SUBJECT: GRAND GULF NUCLEAR STATION, UNIT 1 – STAFF ASSESSMENT OF
RESPONSE TO 10 CFR 50.54(f) INFORMATION REQUEST – FLOOD-
CAUSING MECHANISM REEVALUATION (TAC NO. MF1102)

STAFF ASSESSMENT BY THE OFFICE OF NUCLEAR REACTOR REGULATION

RELATED TO FLOODING HAZARD REEVALUATION REPORT

GRAND GULF NUCLEAR STATION, UNIT 1

Figure 2.2-1: Flood Event Duration

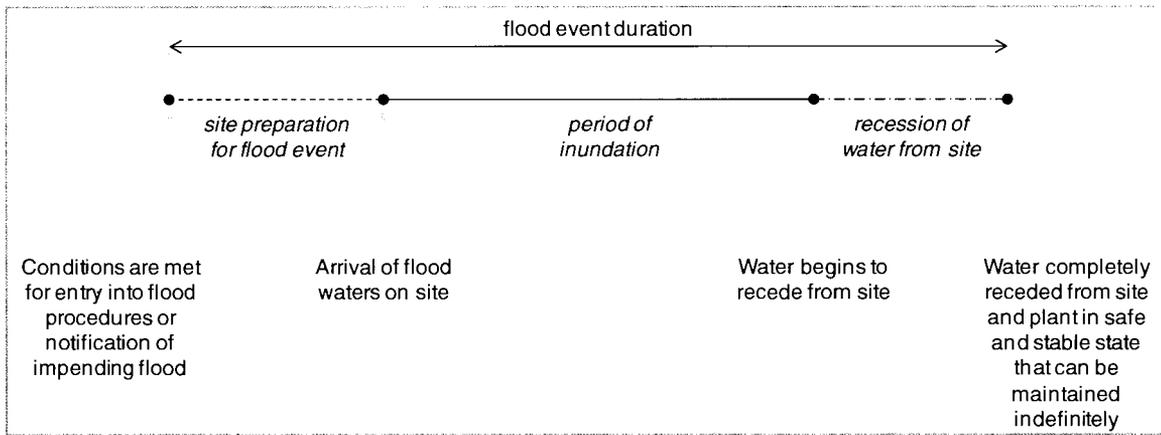
The staff requested, via RAI No. 4.0-1, the licensee to provide the applicable flood event duration parameters associated with mechanisms that trigger an Integrated Assessment. The relevant flood duration parameters include the warning time the site will have to prepare for the event, the period of time the site is inundated, and the period of time necessary for water to recede off the site for the mechanisms that are not bounded by the current design-basis. The licensee's response, dated January 9, 2014 (Mulligan, 2014), states that the site is only inundated by LIP events and that the LIP flooding, which is the controlling flood mechanism for GGNS Unit 1, exceeds the design-basis. The licensee noted that LIP flooding will be included in the Integrated Assessment.

In Figures 3.1-6 through 3.1-19 of the FHRR, the licensee indicated that the maximum LIP inundation depth would occur in front of the "OCT5" door, which is located between the Unit 1 and 2 Reactor Buildings and leads into the Control Building. In addition to the flood warning time provided by the response to RAI No. 4.0-1, the staff determined the following LIP flood duration parameters based on the simulated LIP hydrograph provided by the licensee (see Figure 3.1-16 in the FHRR):

Figure 3.2-1: Site map with FLO-2D model grid, where brown color grid cells indicate building areas designated as area reduction factors (from the response of RAI 3.2-1 (Mulligan, 2014).

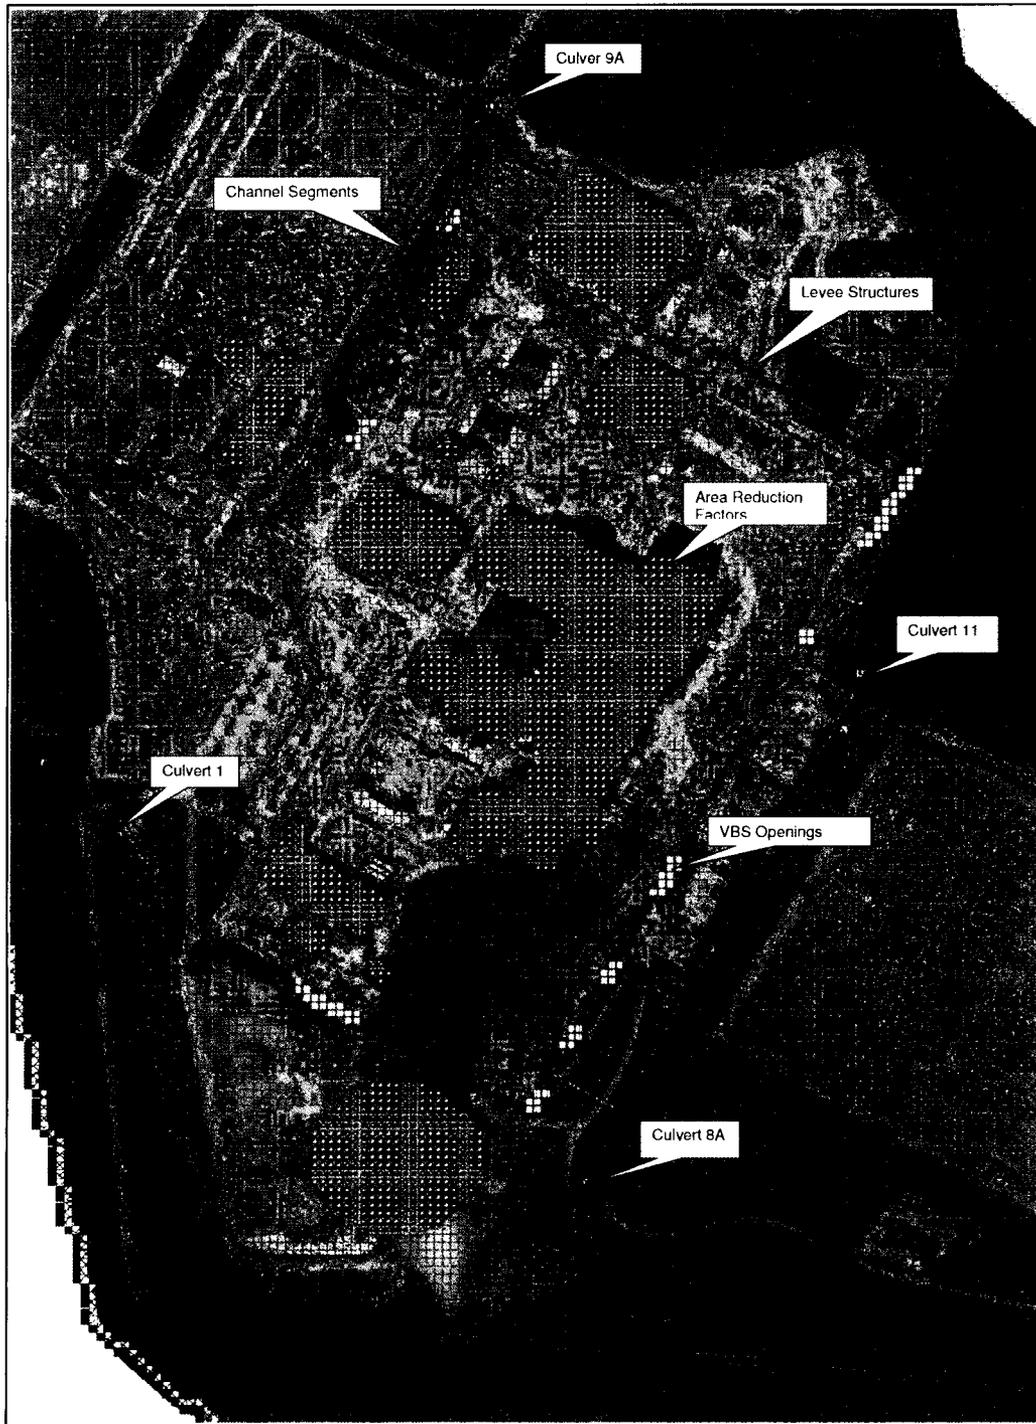
The VBS was represented as a levee in the FLO-2D model and the licensee considered two types of openings in the barriers. The licensee assumed that small 0.6 ft-diameter (0.2 m diameter) VBS openings were completely blocked. The licensee modeled larger openings in the VBS using hydraulic structures in the FLO-2D model, assuming those openings to be 30 percent blocked by debris on security screens. Depth-discharge relationships for VBS openings were developed in CulvertMaster. For FLO-2D input, the discharge associated with the “depth” (difference in water-surface elevation inside and outside the VBS) at each VBS opening was reduced by 30 percent.

- Integrated Assessment Open Item 1a: In the FHRR, the licensee stated that buildings were represented as obstructions to flow, but provided no description of how precipitation falling on building roofs was represented in the model. The staff found that, in the licensee's FLO-2D model, precipitation falling on roofs did not enter the overland flow domain on the ground. The staff also identified additional modeling issues related to the LIP FLO-2D simulations, such as inaccurate water budgets and unrealistic stage hydrographs (e.g., FHRR Figures 3.1-9, 3.1-10, 3.1-14, and 3.1-16), which show high flood stages even after the ending of the postulated PMP event.

- Integrated Assessment Open Item 1b: The staff could not verify that the 50 percent culvert blockage was appropriately implemented in the FLO-2D model. The licensee is requested to clarify how the reduced culvert discharge had actually been modeled for Culverts 8A, 9A, and 11. The licensee is also requested to clarify that Culvert 1 was configured as described by the licensee in its FHRR and RAI responses.

Figure 3.3-1: Stream A and Stream B basins obtained from Figure 2.4-8 of UFSAR Unit 1 (2012).

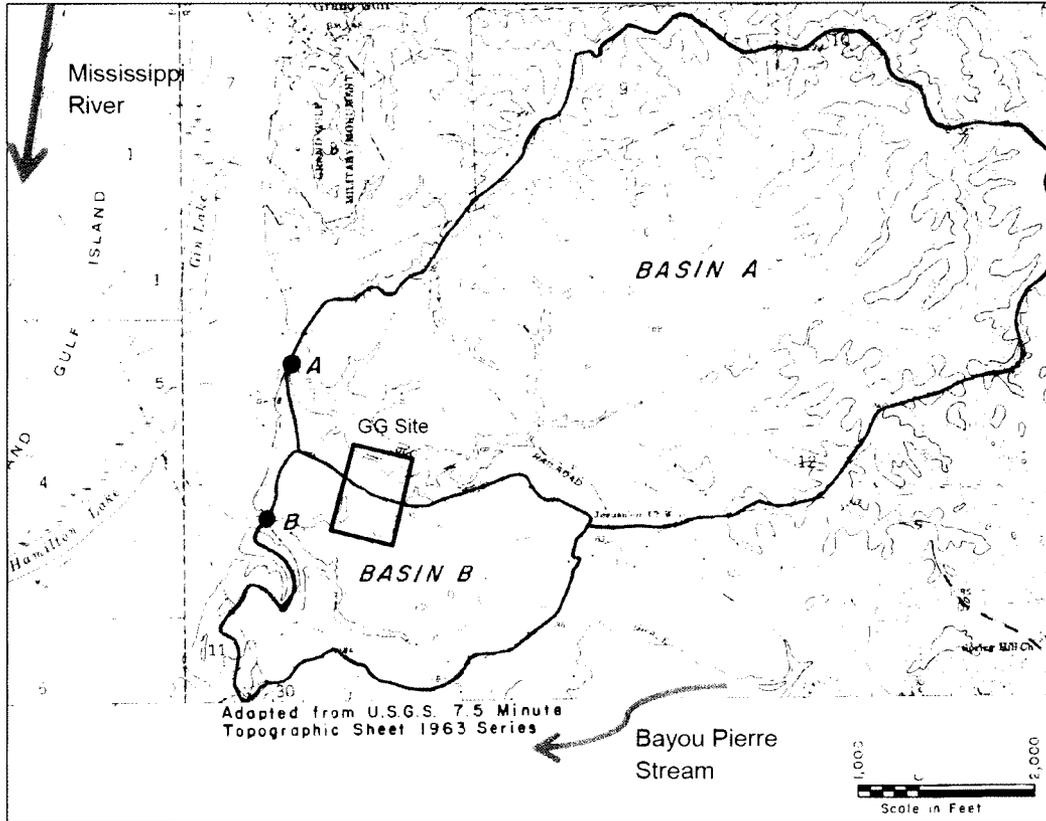
The licensee evaluated the PMF on Stream A and Stream B (see Figure 3.3-1) by: obtaining the basin PMP values using HMRS 51 (NOAA, 1978) and 52 (NOAA, 1982); simulating basin outlet PMF rates using the Soil Conservation Method programmed in HEC-HMS (USACE, 2000) to simulate basin runoff for ungagged streams and assuming no infiltration or evaporation losses conservatively, and; estimating water elevations associated with the simulated PMF rates using FLO-2D that routes both one-dimensional channel flow and two-dimensional overland flow on the vicinity of the plant site.

The staff noted that the northern portion of the onsite drainage channel is connected to Stream A while the southern portion of the onsite drainage is linked to Stream B. The staff also noted that the estimated PMF levels on both streams which are lower than the plant grade are higher than the invert elevations for onsite drainage channel outlets. Because of these site configurations and a PMP event could be applied to all three basins, the staff determined that a combined flood from onsite and basins for Stream A and Stream B could be plausible and more severe than individual floods. In RAI 3.3-4, the staff requested the licensee to provide an analysis of a combined flooding event from onsite and drainage basins for Stream A and Stream B, or to justify why the combined flooding event is not plausible using appropriate topographical and structural data (NRC, 2013c). In response to RAI 3.3-4 (Mulligan, 2014), the licensee described that the PMF determined for Streams A and B includes the site as a contributory area, but with a shorter runoff lag time because (1) the onsite area is mostly paved and (2) the reach of the onsite drainage channel is relatively shorter than those of the streams. The licensee noted that the maximum water surface elevations within the plant site resulting from LIP are not expected to be influenced by floods on Streams A and B. The staff reviewed the licensee's model inputs and outputs related to the Streams A and B analyses and agreed with the licensee's statement that the onsite LIP flood is not influenced by PMFs on Stream A and B mainly due to the difference of peak discharge arrival times at the basin outlets.

Figure 3.4-1: Bayou Pierre basin with dams (blue dots)

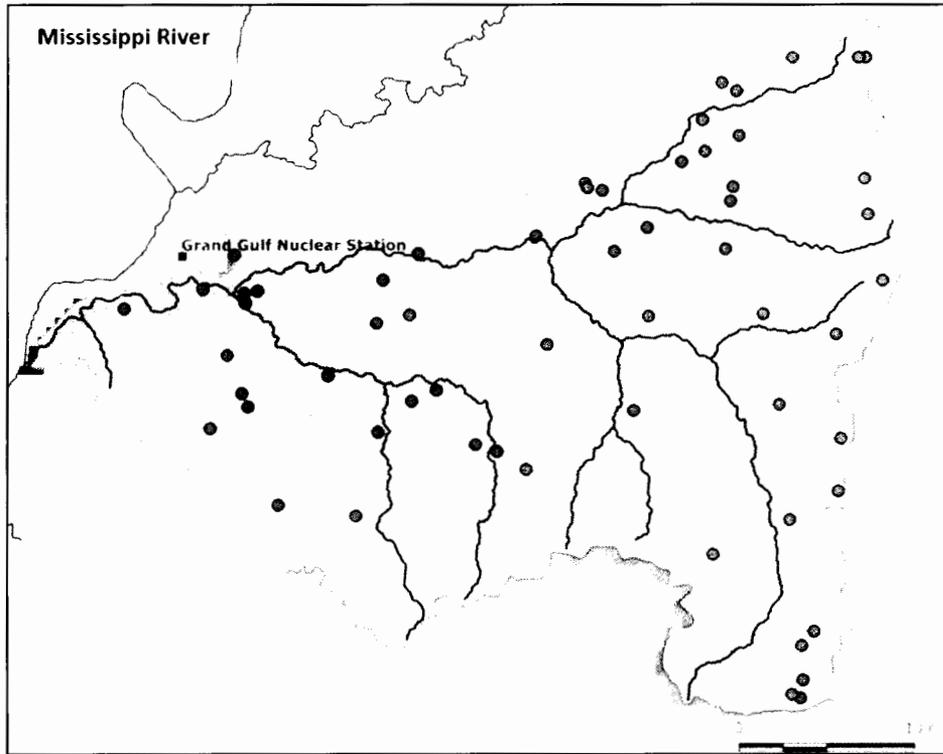
The staff also performed a simple bounding dam failure flood analysis on the Bayou Pierre. The staff identified from the NID Database (USACE, 2013) a total of 59 dams within the Bayou Pierre basin as shown on Figure 3.4-1. The total storage volume of these dams is 34,149 ac-ft (42.1 km³), and the maximum storage volume of 15,489 ac-ft (19.1 km³) for the Lake Calling Panther Reservoir on the eastern upstream of the basin. The staff assumed that all dams fail and discharge water to the basin outlet simultaneously without loss. The staff estimated the peak dam failure outflow using the bounding breach peak flow equation by Froehlich (1995). The resulting sum of the peak breach outflows was 641,853 ft³/s (18,175 m³/s). Adding the peak breach flow to the basin PMF rate, the staff obtained a total combined flood rate of approximately 1,376,000 ft³/s (38,964 m³/s), which was a significant increase compared to the PMF-only rate.

Therefore, in RAI 3.3-3, the staff requested the licensee to provide an analysis of a combined event of PMF, dam failure, and other applicable flood causing mechanisms, or provide a justification if such event is not plausible. In response to this RAI, the licensee stated that Bayou Pierre is not anticipated to overflow the watershed divide between its basin and the site. The staff reviewed the relevant information (see discussion in Section 3.9, below) and agrees with the licensee's conclusion that flooding from Bayou Pierre would not overflow the watershed divide separating it from the GGNS site.
